## Control Message Update v2

Dave Olsen 7/19/2012

# CAN Extended

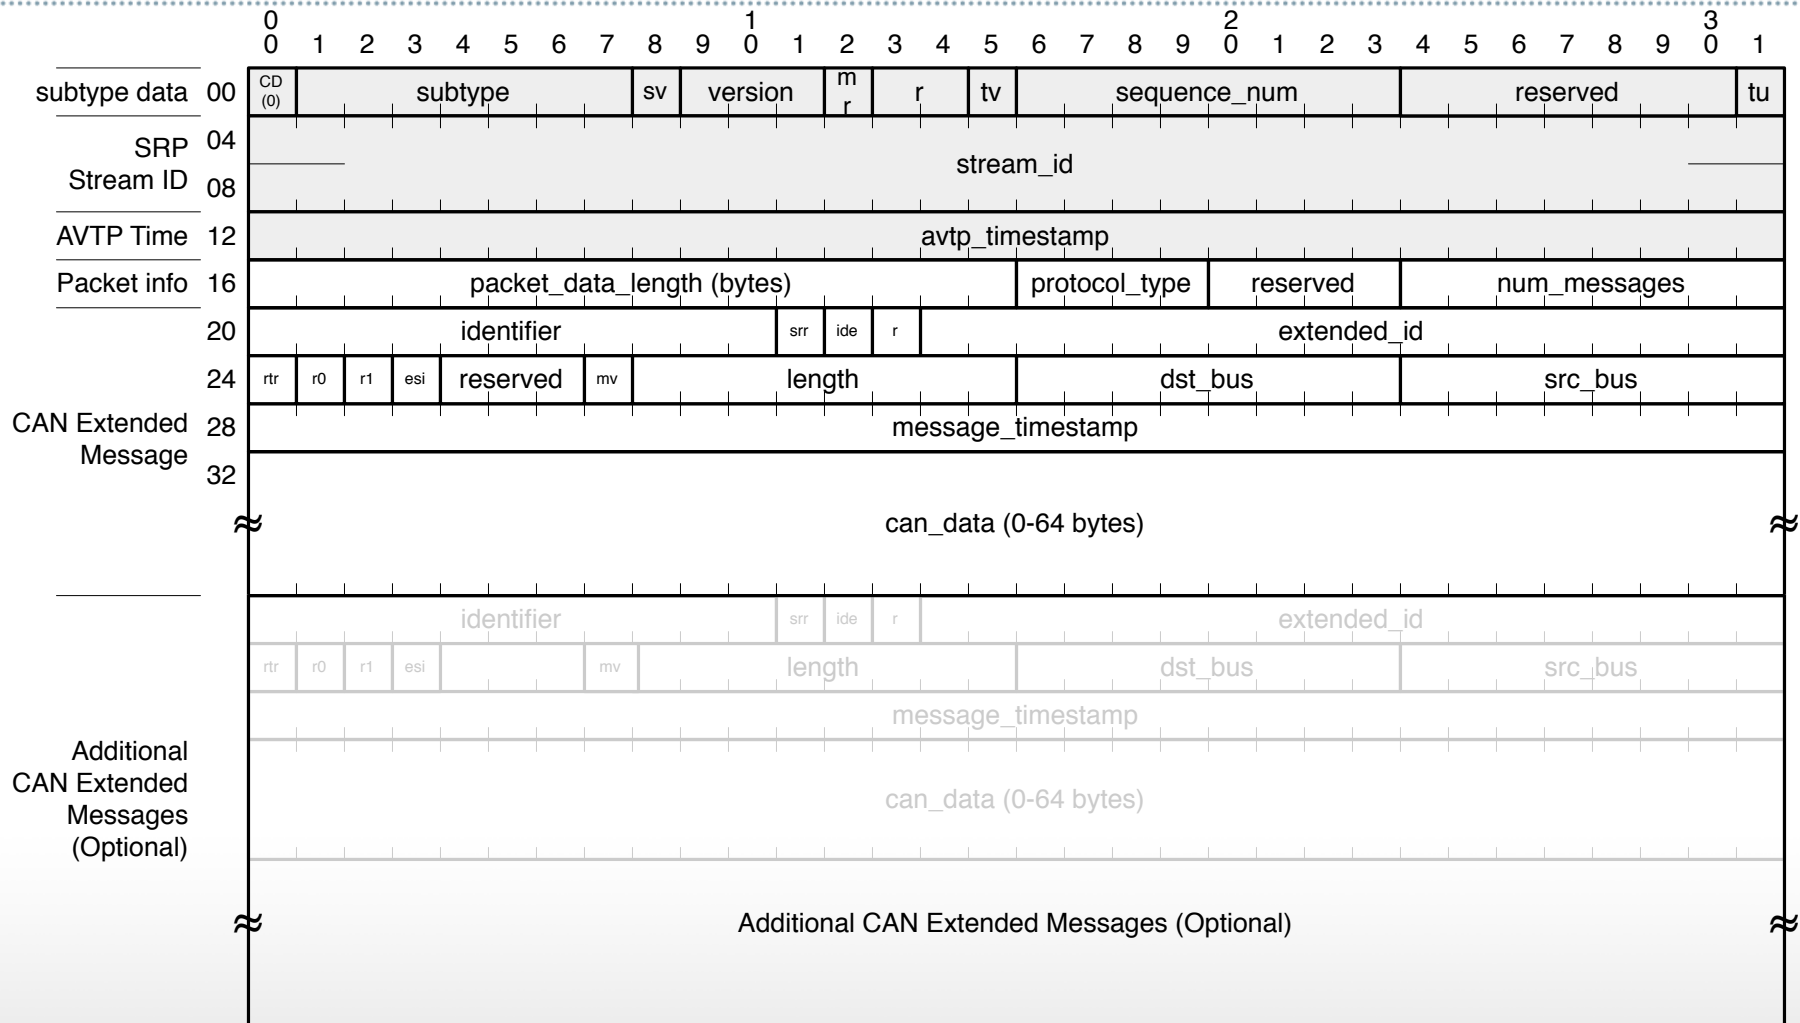
- 
- **Source and Destination Bus fields change to 8 bits**
  - **Timestamp per message**
  - **Normalize Length fields**
